Service Notification

Elimination of Noise in Radio from Dynon SkyView SV-D1000

SN-ASTM-CTLS-02

Fig. 3

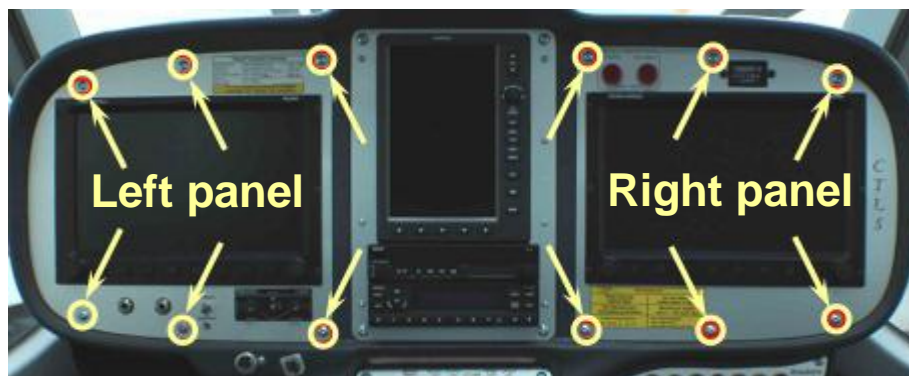
1. Unscrew 6 screws of the left panel, shown on Fig. 3, using 3 mm Allen key. Remove the left panel of the instrument console.

5. Install the left panel of the instrument console by screwing the 6 screws of the left panel, shown on Fig. 3, using 3 mm Allen key.
